DELEGATED APPLICATION REPORT

App Ref: PL/25/1673 Full planning permission

Address: 5 STONEHAM CLOSE, TILEHURST, READING, RG30 4HB

Proposal: New dwelling to the rear of No.5, replacing existing garage, including parking and landscaping

Photo 1 in Arb Report

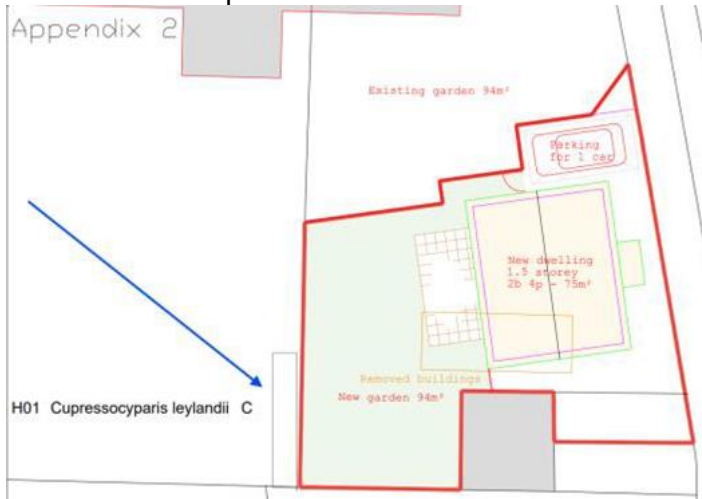
Firstly, I note that the majority of the previously existing boundary vegetation has been removed from the site, some of which was previously proposed to be retained. The extent of this vegetation removal is unclear, as this has been undertaken prior to the Arboricultural Report being written. This is disappointing as for the previous application, I expressed concerns regarding the clarity of vegetation removal. I am now concerned that as the vegetation removal has been undertaken prior to the submission of this application, this makes the extent and impact of the vegetation removal even more difficult to assess and sufficiently mitigate. The only vegetation retained is H01 along the southern boundary.

It is clear from Photo 1 and Photo 2 of the Arboricultural Report that vegetation clearance has taken place – see below.

Photo 2 in Arb Report

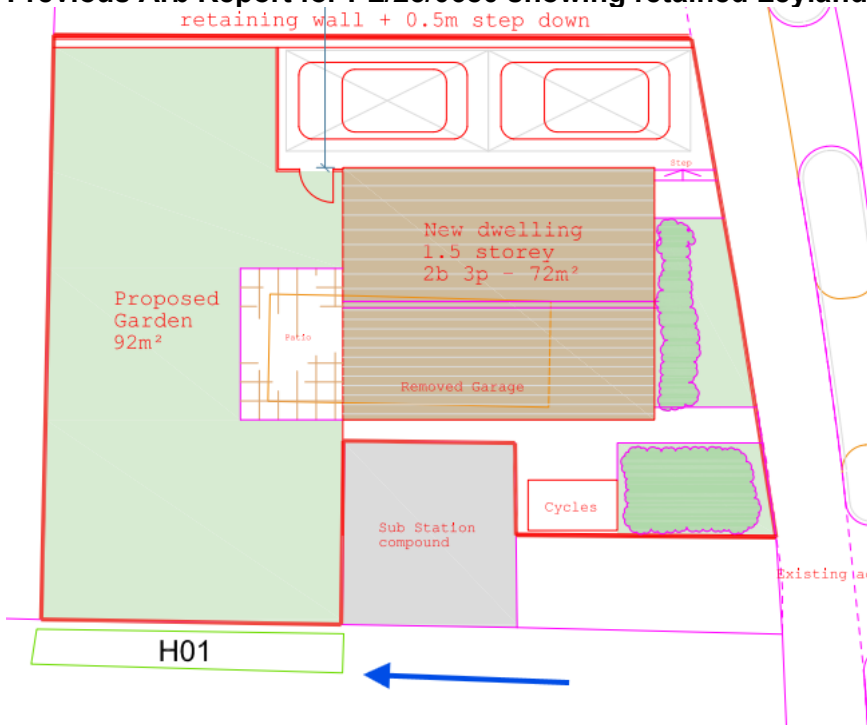
4.2 states '*There are no RPAs issues*' – RPAs have not been plotted but new landscaping is proposed in close proximity to H01 so I am unclear how this conclusion has been drawn.

3.4 states '*There are no off-site trees close to the boundary*'. I note a clearly large Willow tree in adjacent land in Photo 2. It is a large tree and in somewhat close proximity to the rear of the development (iShare gives an estimate of less than 10m – all trees need to be plotted within 15m of any part of the area being developed [landscaping included]). It is expected this tree and its RPA is plotted to demonstrate it does not extend into any part of the development area/boundary to provide evidence that its RPA will not be impacted. If its RPA was to extend into the development site, tree protection will be required. If excavation is required for the landscaping in the RPA i.e. levelling the ground level, then appropriate working methodology for working within RPAs will need to be demonstrated. I assume the ground of the rear garden will be levelled as there is a retaining wall along the northern boundary. For absolute clarity, we require this tree to be surveyed and its RPA plotted, so that any impact can be demonstrated and mitigated, or providing us assurance that the RPA does not extend into the site.

Proposed Habitat Map showing both southern and western boundary hedges retained.

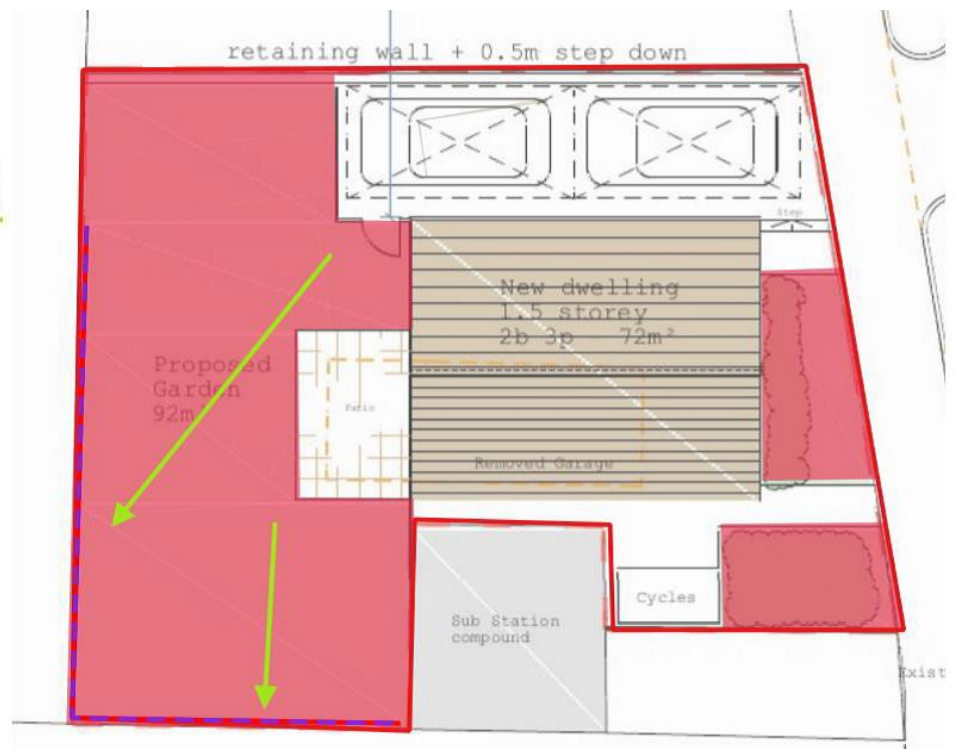
I note both these hedges on southern and western boundary have been included Biodiversity Net Gain Assessment, November 2025 and the associated Proposed Habitat Map, Drawing No. 8132-XX-E0-02, Issue: v1 24th November 2025, and are shown as retained and connected.

The Proposed Habitat Map also describes the proposed garden as a 'vegetated garden'. With reference to the Proposed Site Plan, April 2025, Drawing No. 02-10, Rev C, I note this garden appears to be just a lawn area with a patio. There are no labels to clearly demonstrate that this is a lawn, however it is assumed as it is shown as a green space. With reference to Ground Floor Plan, March 2025, Drawing No. 03-10, Rev C, I note some new shrub planting on the frontage which is clearly labelled and positive.

I am unclear as to why no new planting has been indicated in the rear garden, or even labelled as a grassed area.

It would be reasonable to request a proposed vs existing landscape principles plan which clearly demonstrates the changes to the landscaping. This should include vegetation removal/retention (specifically to clarify the southern and western boundary hedging situation). New hard surfacing and associated materials should also be clearly demonstrated and labelled. It is also expected to demonstrate new planting; as the rear garden is described as vegetated and has space for planting other than just a lawn area, new planting here is expected to mitigate for the loss of the existing soft landscaping and increased development.

1082 03-10 Rev C floor plans

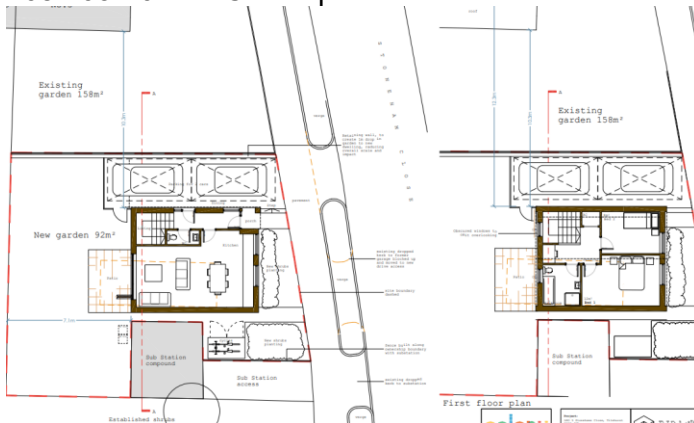
The proposed appearance is proposed to match the materials of the existing dwelling however the proposed plan 1082 05-10 b does not reflect the appearance of 5 Stoneham Close. A condition for further materials specifications would be required if the proposal is considered acceptable to ensure that the materials will be in keeping with other properties along Stoneham Close. 5 Stoneham Close has a semi-detached 'chalet' style asymmetrical catslide roof that slopes downwards over the front left hand side to the ground floor, with a more layered and incremental appearance than the proposed two storey box style with no dormers or catslides. The new dwelling is proposed to have a similar form as surrounding houses on Stoneham Close, however would have a different roof form and differing proportions of brick and cladding which has been contrived to fit into a constrained site.

The amended proposal fails to overcome the previous concerns in appearance with a proposed box design with minimal fenestration to the frontage, and limited opening to the sides. The proposal would be a full two-storey dwelling, set down ~1m from the ground floor level of no.5 Stoneham Close. The ridge is purported by the agent to approximately match that of no.5 and 4 Stoneham Close however it is in a different orientation for the proposed house. An AA section plan has been provided however there is a lack of topographical information on the streetscene drawing. The parked car for the new dwelling is shown below the pavement level with no indication of how the access will be constructed and align with the pedestrian footpath. It is unhelpful in allowing the impact to be assessed and as such the applicant has failed to demonstrate that the design would be acceptable relative to the sloping nature of the site and adjacent access.

There are irregularities with the plans submitted as the front elevation windows do not match the floor ground or first floor plans and the long window as shown on the rear elevation is not shown on the ground floor plan.

Plan from the Council mapping shows the substation land, this can be compared to the plan provided by SSE as shown above:

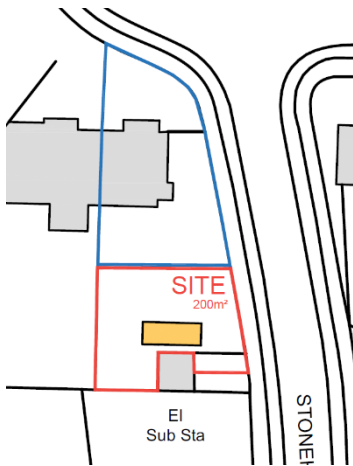
The land ownership is unclear. It appears that part of the substation land has been included within the site location plan, however a Part A certificate of ownership declaration has been made. The applicant has provided no evidence of prior notification to SSE.

Location plan submitted by the applicant

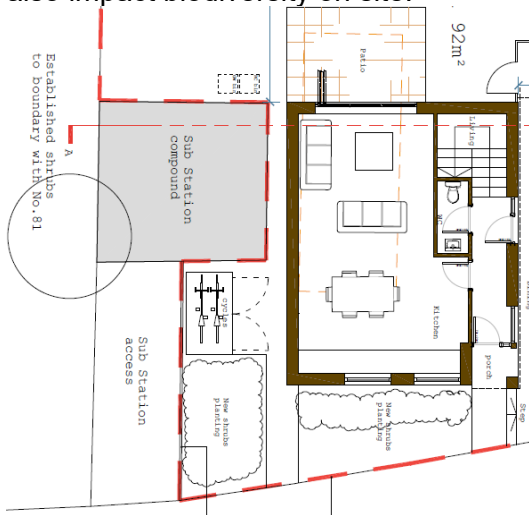
Landscaping and a cycle store are shown to be located within the SSE sub-station land, this would also impact biodiversity on site.

6. Land ownership and rights of access to land on which the electric substation is sited should be established as this appears to fall within the red line boundary. A certificate of declaration A has been provided for development proposed as part of the existing planning application. Landscaping and cycle storage is shown on the proposed plans in front of the substation.
